## **REFERRAL RESPONSE – URBAN DESIGN**

FILE NO: DA 602/2009/1

ADDRESS: 8 Castra Place DOUBLE BAY 2028

PROPOSAL: Replacement of existing fixed wharf structure with berthing for 40 vessels & moorings for 25 vessels with a new floating structure with berths for 45 vessels and moorings for 20 vessels.

FIGURE 1 Density comparison of swing moorings and fixed berths

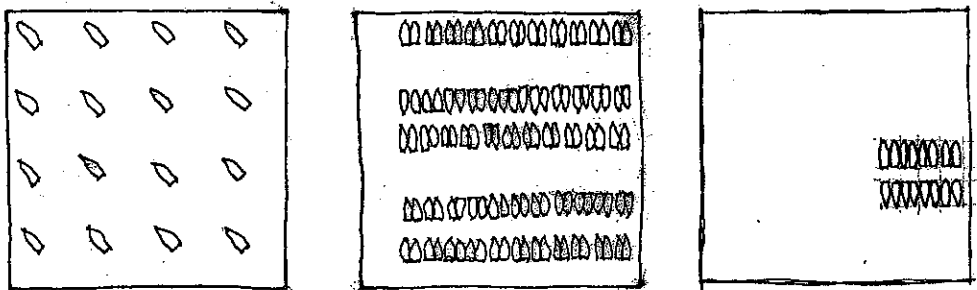
The marina proposal reduces the number of swing moorings by five and increases the amount of vessels at berths by five. A density comparison of swing moorings and fixed berths is instructive. Sixteen boats 10m long can be accommodated on swing moorings in a hectare of water. One hundred and ten vessels 10m long can be accommodated in a hectare of fixed berths. Fixed berths are approximately 6.75 times denser than swing moorings. See FIGURE 1. The density of vessels on swing moorings is controlled by the geometry of the boat's swing, this physical control on density means that swing moorings are visually more permeable than fixed berths.

- The floating pontoons present a lower profile to the sea level.
- The proposal consolidates existing swing moorings into the proposed fixed berth configuration. This changes the nature of the visual impact with the clearing of an area of water of swing moorings. Refer **Figure 1**

**FIGURE 4:** Showing view from the walkway around Redleaf Pool with estimated extent of the extended marina.

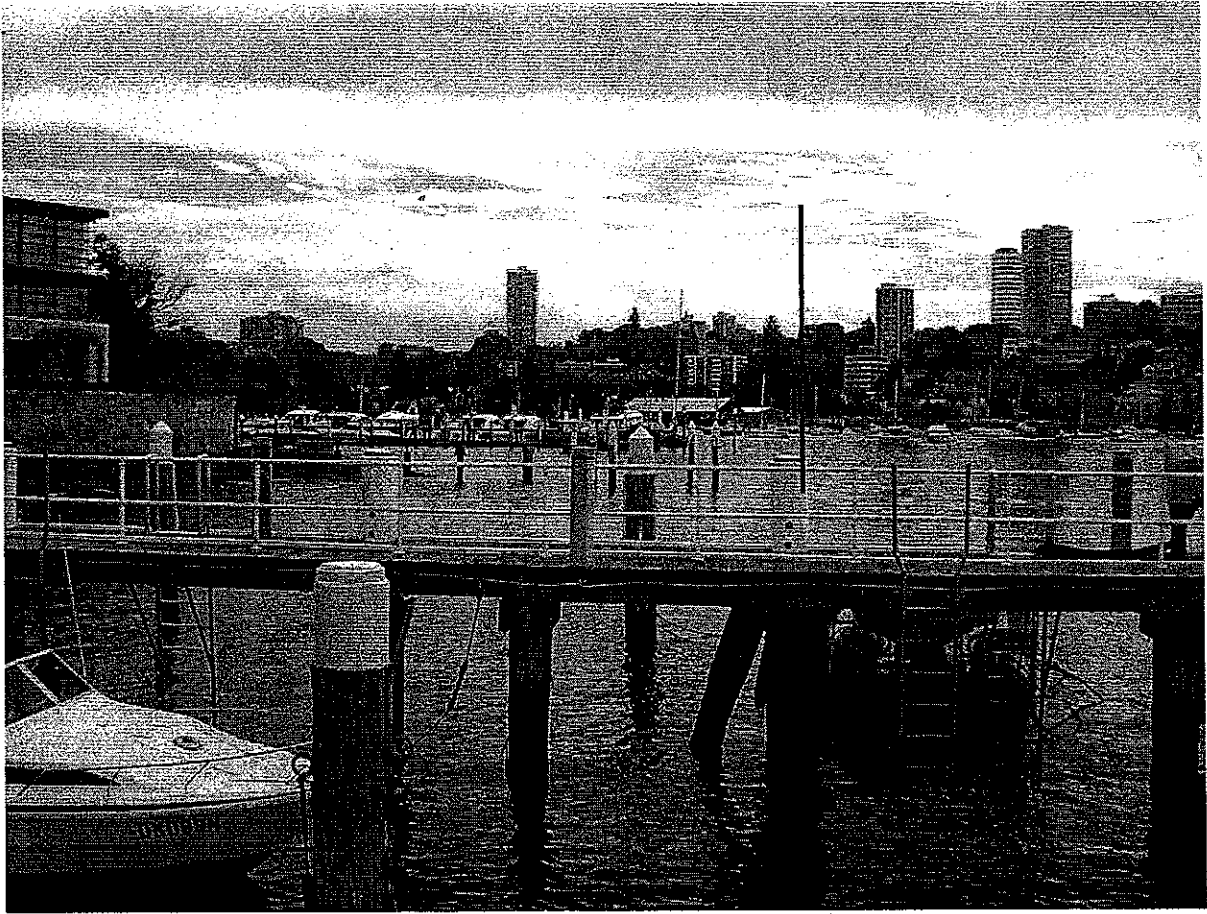
The proposal extends the mooring structures approximately 30m to the North. This means more of the marina will appear from around the headland when viewed from the Seven Shillings Beach.

Redleaf Pool and the adjacent beach and park are well used local amenities. The visual impact is however peripheral to the main aspect.

**FIGURE 5:** Showing view from residential property fronting the beach with the extent of the extended marina marked.

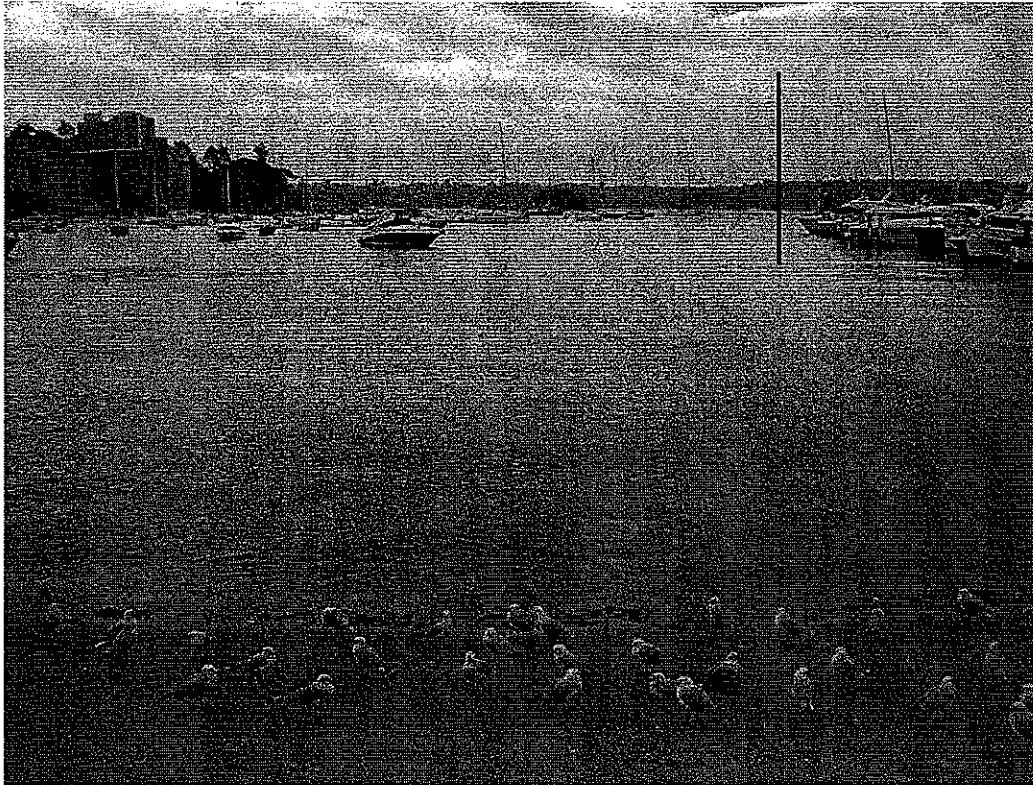
There is very marginal increase in the amount of the harbour view blocked as a result of the proposal.

The waters of the bay are generally unlit. Any lighting beyond the line of the shore is intrinsically intrusive in a natural setting. It is possible that the lights from larger vessels could cause amenity impacts to surrounding residents.

**FIGURE 7: Showing the view from the water, with the extent of the extended marina marked.**  
(This image is copied from the rla report and the extent of the proposed marina has been added)

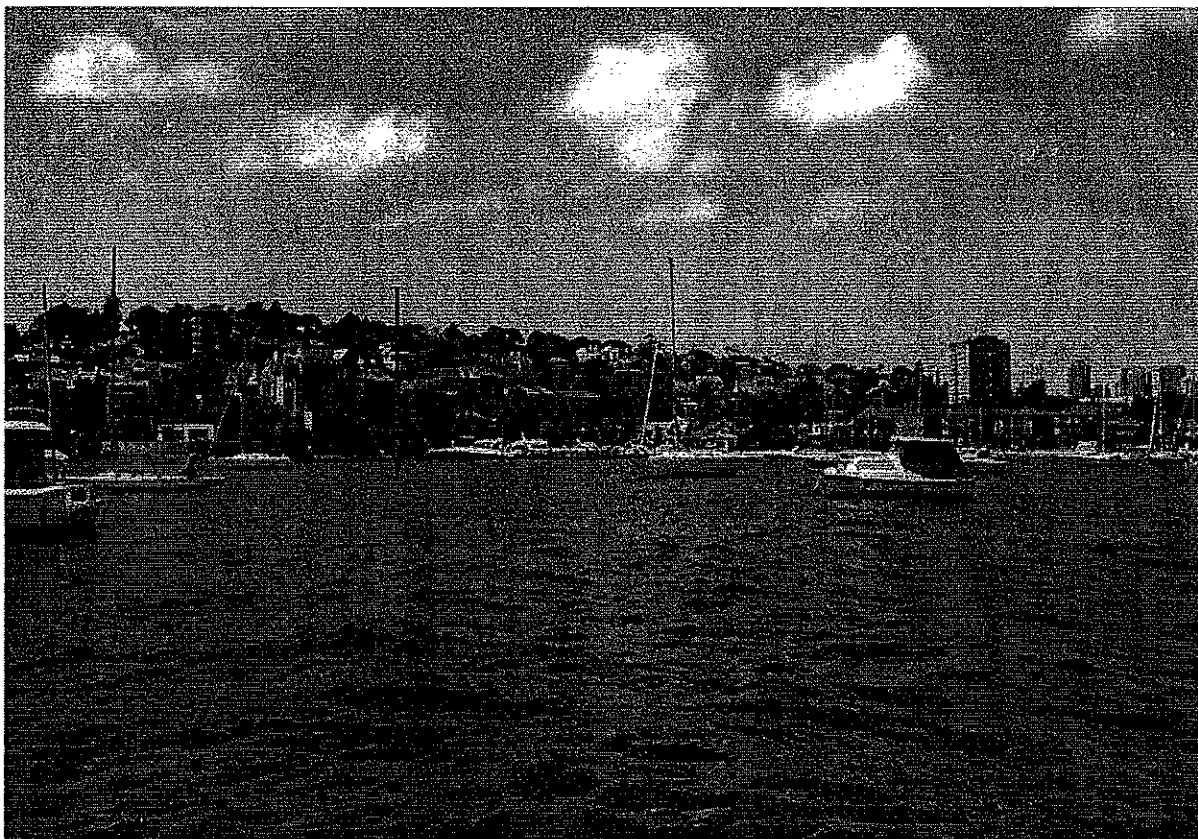
The largest boats in the proposed marinas are berthed on the waterside. The size and number of berthed vessels will mean their visual presence becomes more apparent in the view from vessels and ferries on the waters of the main Harbour and the Bay.

The corner of Double Bay where the proposed extension of the Marina is sited, is formed by a rocky promontory covered in housing. The extension will not have a severe visual impact when viewed against this backdrop.

**FIGURE 8:** Showing view from where the Creek enters the Bay with the extent of the marina marked.

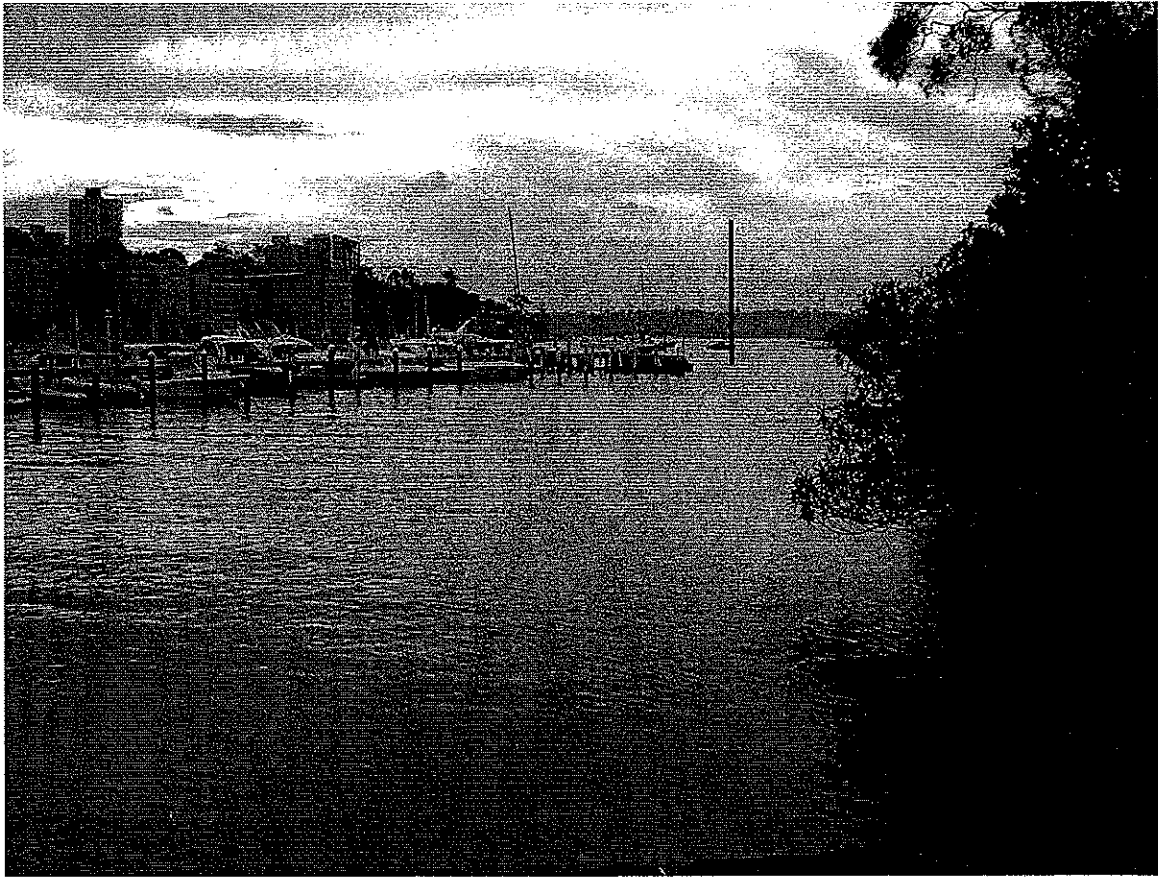
The locating of larger vessels at berths on the end of the proposed pontoon and their reorientation will have a slight impact on views from this point.
